Associated British Ports

Port of Newport – M4 Proposal: Impact on the Port's Mobile Harbour Cranes

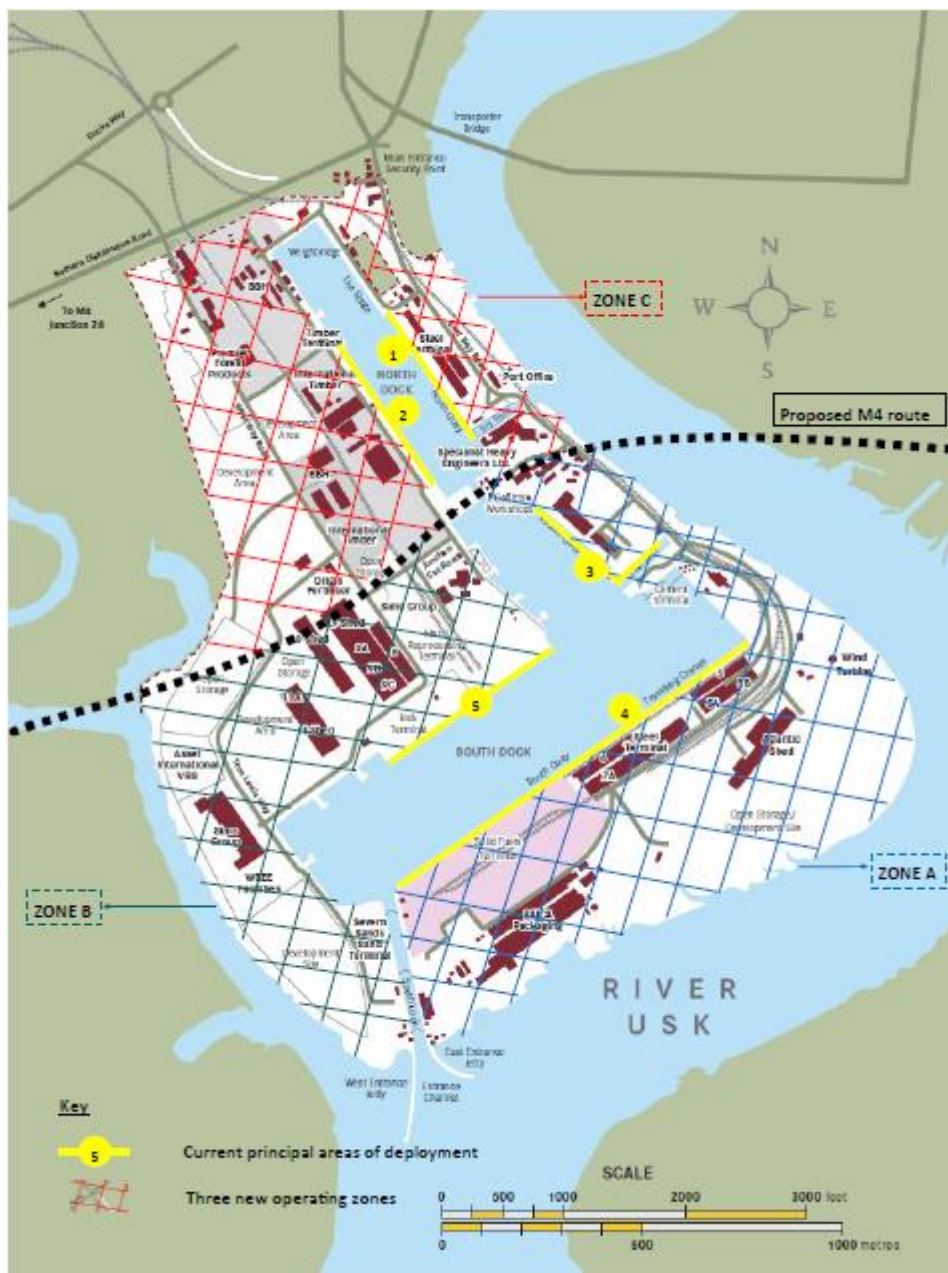
- The eastern side of North Dock – marked '1' below
- The western side of North Dock – marked '2'
- Middle Quay and East Lock – marked '3'
- The south side of South Dock – marked '4'
- The north side of South Dock – marked '5'

- 1.10 In general terms, the proposed M4 bridge effectively splits the Port into three distinct zones – being:
- The south of South Dock and the eastern part of Middle Quay, to the south of the M4 (zone A, denoted by the light blue cross-hatching in the drawing above)

- The north of South Dock (zone B – dark blue cross hatching)
 - The entirety of North Dock (zone C – red cross hatching)
- 1.11 The route that the MHCs must follow to move around the dock, therefore, crosses under the proposed M4 at three primary locations – being East Way Road, West Way Road and Junction Cut Road (to the west of Junction Cut in the vicinity of the International Timber operation). ABP understands that the proposed height of the M4 at these points is 26.98m, 20.09m and 12.13m respectively. The attached Liebherr report also refers to a fourth potential crossing route immediately adjacent to the east of Junction Cut, which passes very close to a working berth and the Engineering workshops, but it is as equally constrained as the East Way Road option and is not currently an approved MHC travel route.
